File Ref: DA201400370

**Manager, Development Assessment reports:**

**Synopsis**

This report concerns an application for the demolition of the existing Chaplain's residence and Glasson Pavilion; excavation to accommodate new underground Old Boys Sporting Complex and carpark for 219 spaces; reconstruction of the Old Boys Oval with synthetic turf; new tennis pavilion and raised tennis court over new vehicle access from Stanmore Road; new college entry forecourt and signage and associated landscaping works at Newington College.

*Image 22: Shadow Diagram – Section B at 2.00pm during midwinter*

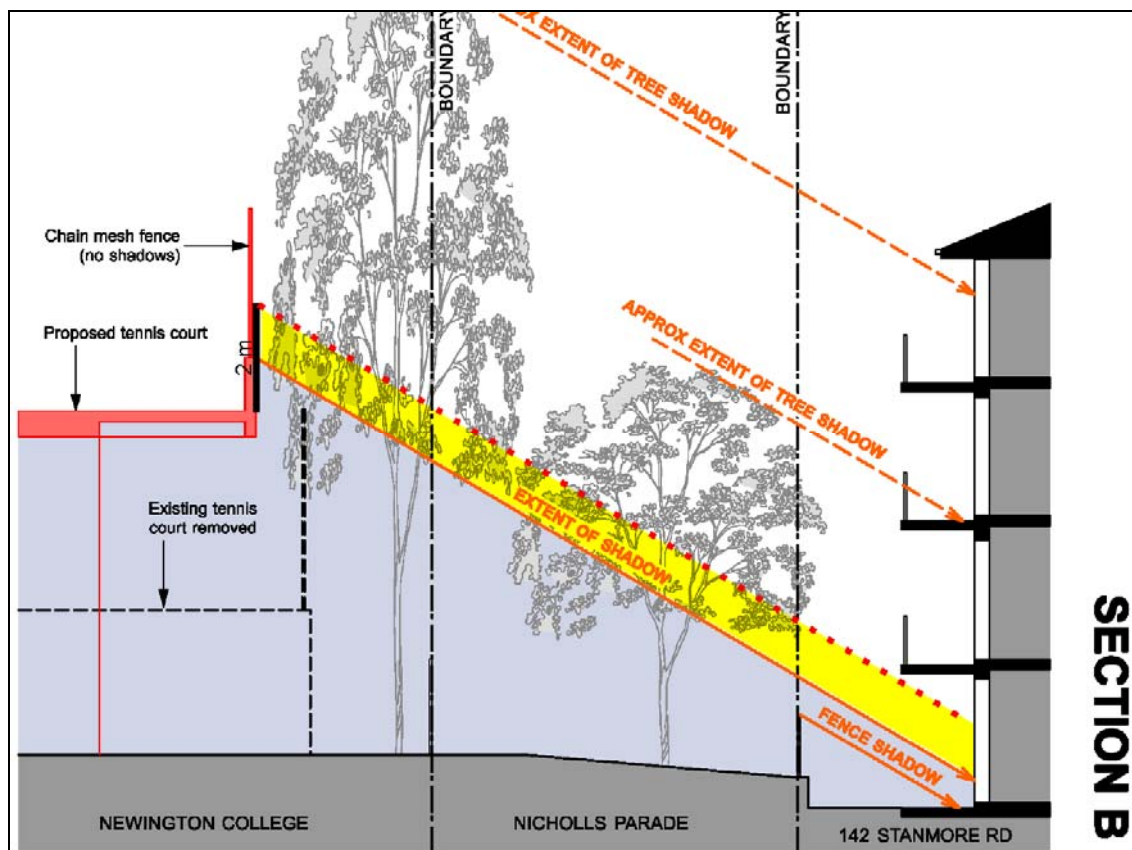
The above section shadow diagram illustrates the additional overshadowing caused by the development on 142 Stanmore Road, including the overshadowing caused by the proposed privacy screening. The affected residential flat building currently receives solar access during midwinter as a result of the relatively undeveloped nature of the site. The adjoining property is generally orientated north-south, which means that the solar access received by the west facing units is only achieved from approximately 11.30am onwards, during midwinter.

The element of the development which causes the overshadowing is approximately 8 metres above ground level and setback 3.5 metres from the side boundary. The adjoining residential flat building has a building height of approximately 10 metres and is setback 3 metres from the side boundary. If the building envelope controls for the adjoining residential flat building were to apply to the development, the proposal could result in a larger structure and have a greater overshadowing impact than currently proposed.

The affected dwelling at 142 Stanmore Road will still receive approximately 1 to 1.5 hours of solar access during midwinter. However, the dwelling will still enjoy greater periods of solar access at other times of the year. Given the orientation of the site and the separation between the developments, the non-compliance of approximately 30 minutes to a single dwelling, which is located at ground level on a 4 storey building, is considered acceptable.

*Image 23: Shadow Diagram – Section C at 2.00pm during midwinter*

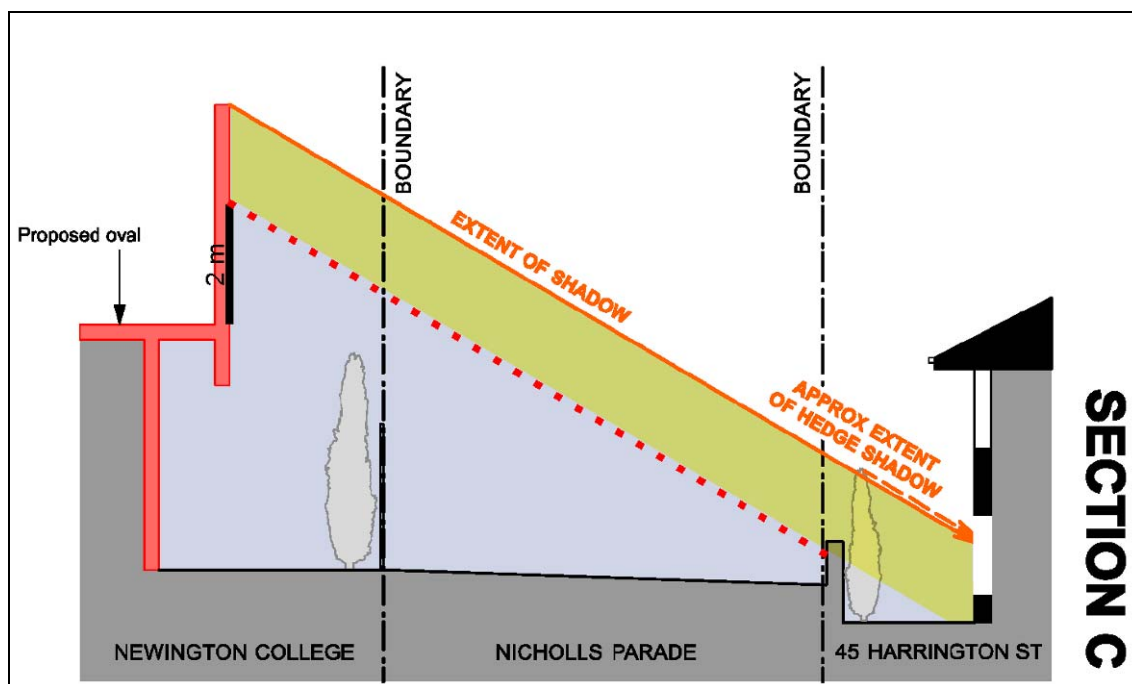
The section shadow diagrams submitted to Council omitted the lower ground floor windows serving the dwelling at 45 Harrington Street. The above section shadow diagram illustrates the approximate location of these windows and the overshadowing impacts caused by the development.
